TOLEDO - LUCAS COUNTY PLAN COMMISSIONS

REF: SUP-6001-24

SUBJECT: Special Use Permit for expansion of a Day Care Center at 1219 Warwick Avenue

SITE PLAN

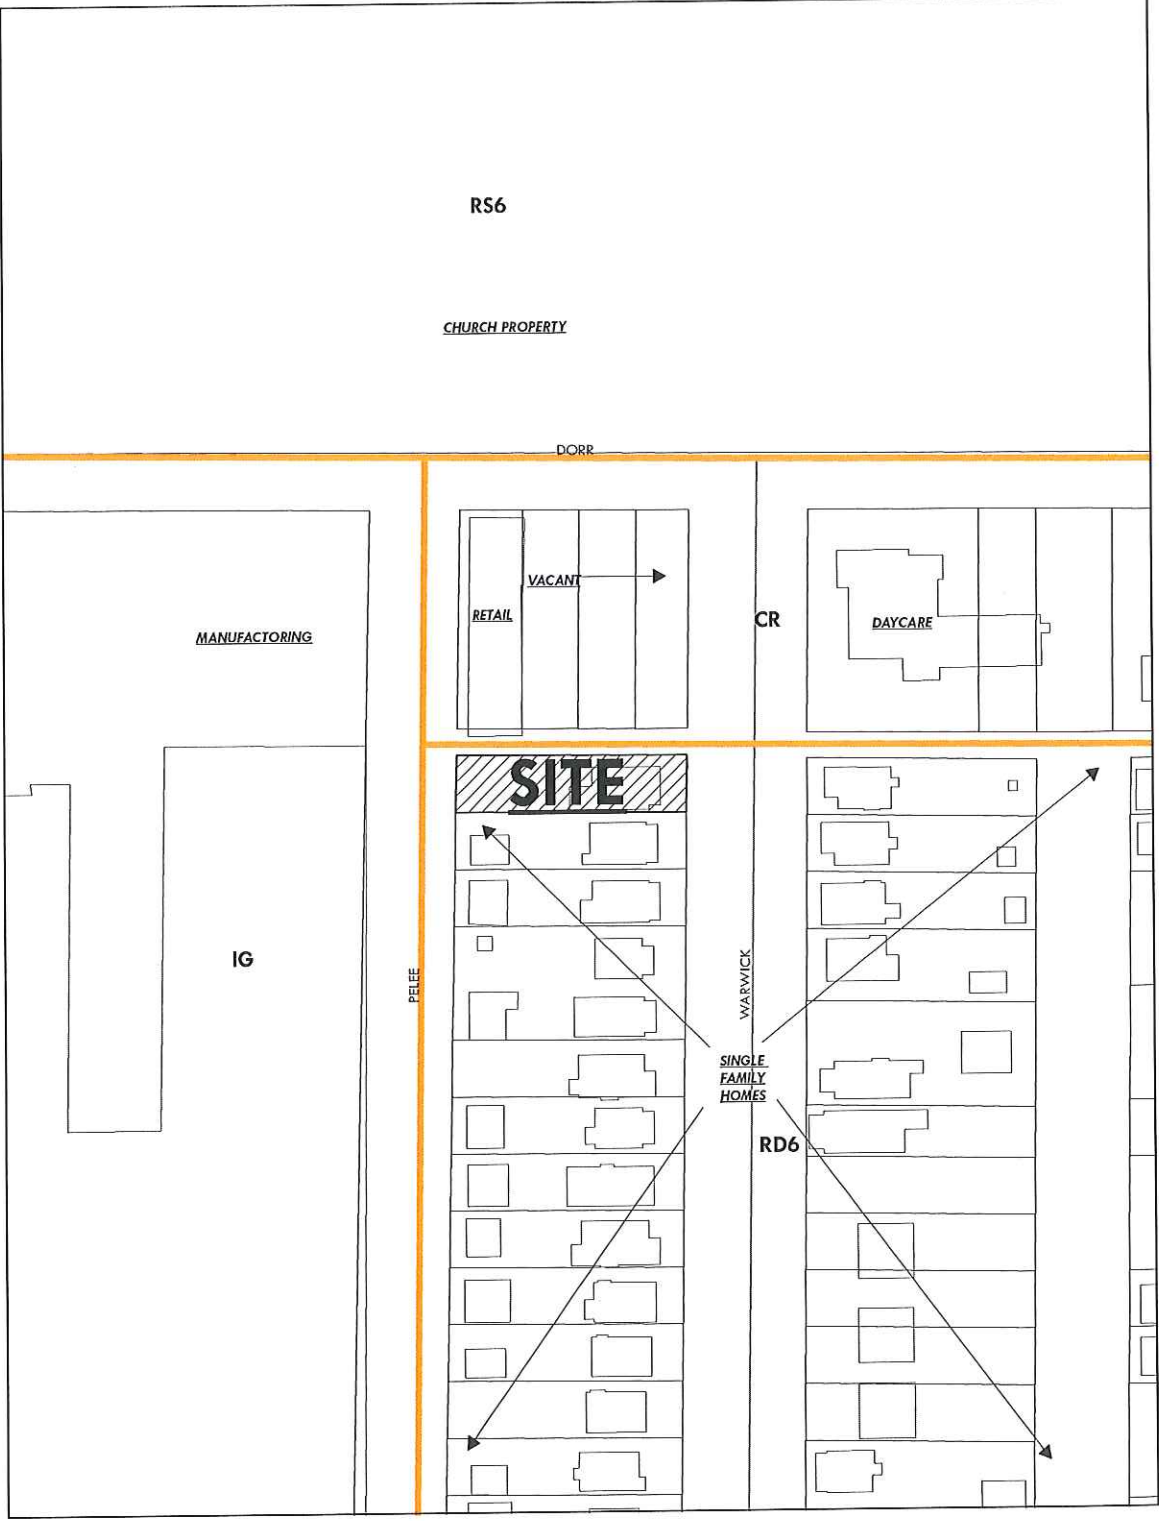
- b. A five-foot six-inch (5'6") buffer of landscaped frontage is required along Warwick Avenue. At least one tree must be provided for every 30 feet of lot frontage. A total of six (6) trees are required along Warwick Avenue on this site. **Not acceptable as depicted. An additional tree is required and shall be shown on a revised landscaping plan.**

- c. A five-foot six-inch (5'6") buffer of landscaped frontage is required along Pelee Street. At least one tree must be provided for every 30 feet of lot frontage. A total of two (2) trees are required along Pelee Street on this site. **Not acceptable as depicted. An additional tree is required and shall be shown on a revised landscaping plan.**

- d. A Type A landscape buffer is required along the northern property line abutting 2345 Dorr Street (Parcel# 11-31094). With a solid fence, one (1) tree and five (5) shrubs are required for this site. **Not acceptable as depicted. One (1) tree and five (5) shrubs are required and shall be shown on a revised landscaping plan.**

- e. A Type B landscape buffer is required along the southern property line. Five (5) trees and eighteen (18) shrubs are required. **Not acceptable as depicted. An additional tree and eighteen (18) shrubs are required and shall be shown on a revised landscaping plan.**

- l. Unless a BZA waiver is granted, fences shall not exceed 3½ feet in the front yards along Dorr Street and Warwick Avenue. **Not acceptable as depicted. Staff recommends applicant obtain a BZA waiver to allow fences to exceed 3½ feet after a twenty-foot (20') setback along Warwick Avenue (the required front yard).**
